NISSAN BULLETIN

Starter Motor Wire Dealer Inventory Inspection

Reference: PC440

PC440 Frontier (D40) Starter Motor Wire Position Inspection

Figure 4

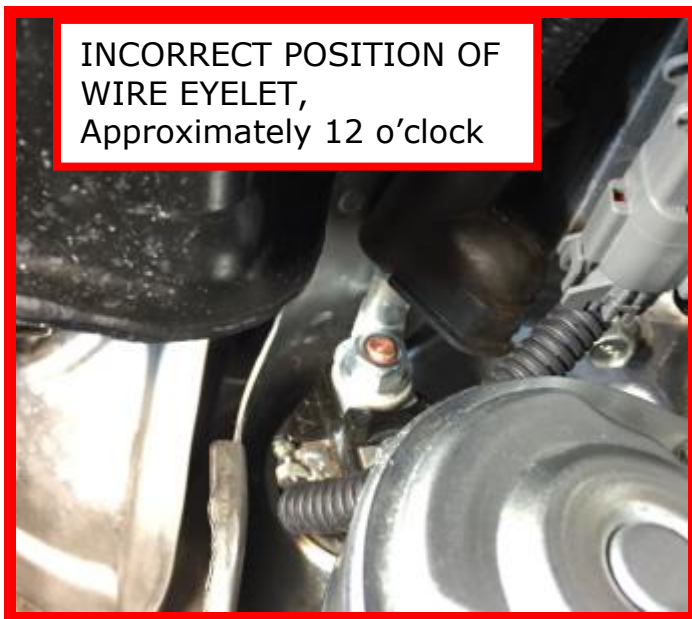
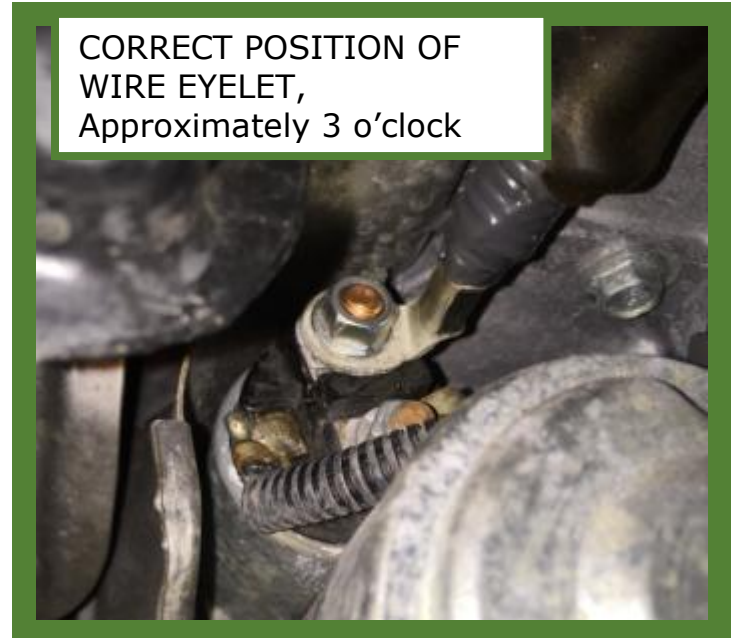
6. Inspect the starter motor wire eyelet.

A. If the starter motor wire eyelet is in the **CORRECT** position (Figure 4):

B. If the starter motor wire eyelet is in the **INCORRECT** position:

- Loosen the starter motor wire nut and re-position the starter motor wire to be orientated as in Figure 4 above.
- Torque the starter motor wire nut:
11.0 Nm (97.0 Inch Lbs.)
- Gently push the terminal protective boot back over the nut and wire.
- Lower the vehicle off the hoist.
- Reconnect the negative battery cable.
- Submit a warranty claim using PC4401 per claims information, below.
- Release the vehicle.
